Product Advisory

Supply continuity. BOM component change only.

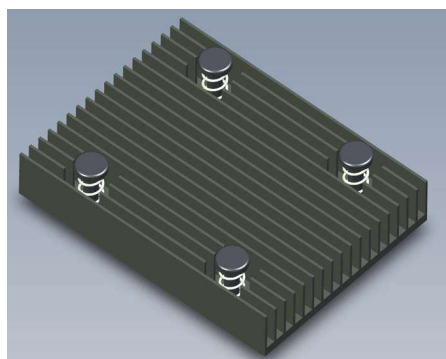
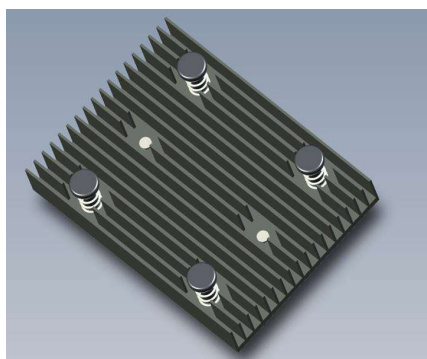
The heatsinks used on the adapters listed in the table below are being updated to remove the heatsink detection logic pins, also known as TOGO pins. The pins supported a now deprecated feature used to detect if the heatsink is missing. The picture on the left is the existing heatsink with TOGO pins and the picture on the right is new heatsink without the TOGO pins.

The heatsink detection feature has been deprecated

The adapter specification will remain the same. No changes to adapter form, fit, function, quality and reliability.
